## Determination 2010/83

### The compliance of proposed remedial work to window jambs on a house with monolithic cladding at 164 Quail Road, Kanohi, Rodney District

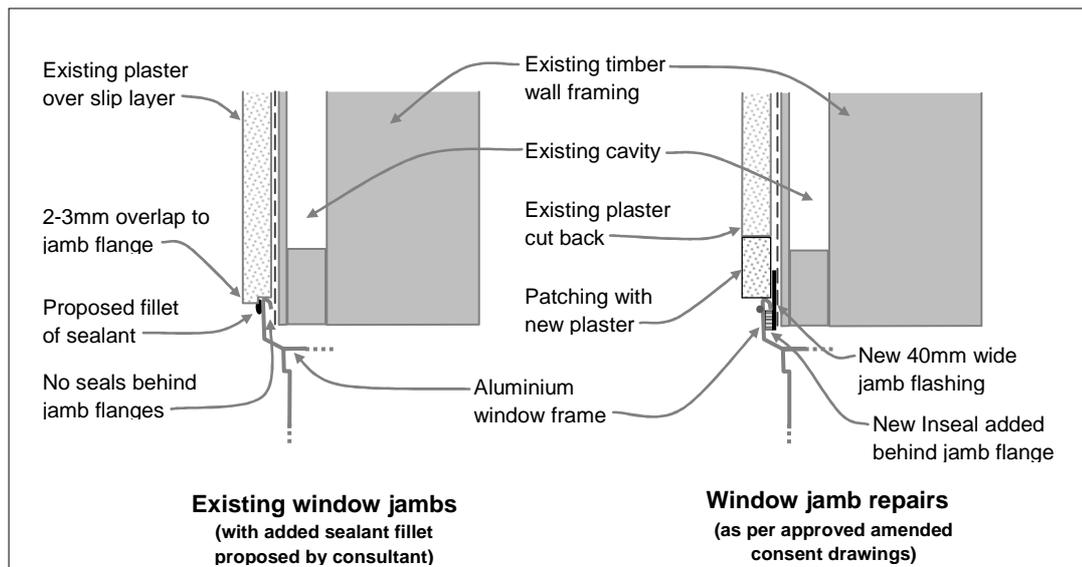
- 3.6.2 The remedial work commenced and, when plaster was removed to install new sill flashings, it was discovered that the jambs lacked flashings or seals behind the window flanges. Due to the difficulty of retro-fitting flashings and seals, the consultant submitted for approval a detail showing a sealant bead applied at the junction of the plaster and the jamb flange.

- the house is in a high wind zone
  - the actual overlap of plaster to the jamb flange shown in the detail appears to be substantially less than the 10mm shown in the proposed detail

- any moisture penetrating the jambs will penetrate into the backing sheets.

- 5.6.2 With regard to the consultant's proposal to face seal the edge of the jamb flange, the expert noted that a sealant bead cannot be applied in accordance with the manufacturer's recommendations for minimum bonding depths and bond breaking tape. At best, any protection offered to the jamb plaster junction would only be a short term solution.

- 6.2.1 Taking account of the expert's report and the above observations, I am satisfied that the proposed sealant repairs to the window jambs will not provide adequate weathertightness and durability, as the edges of the plaster appear to be porous and those edges would still be exposed. However, while I consider that the consultant's proposal is inadequate, I am also of the opinion that the extent of additional work required is mitigated to some extent by the generally adequate past performance of most of the conventional windows.

Council require this 40mm wide jamb flashing to be installed between the head flashing and the sill flashing in accordance with the consented plans as a minimum requirement to meet the performance requirements of the Building Code.

- 6.2.3 I therefore suggest that an adequate level of durable weathertightness of the window jamb junctions may be provided by the addition of appropriate mechanical protection. Should the windows not be removed, then a solution involving an engineered sealant joint protected from sun and rain by an external cover flashing system would be required.
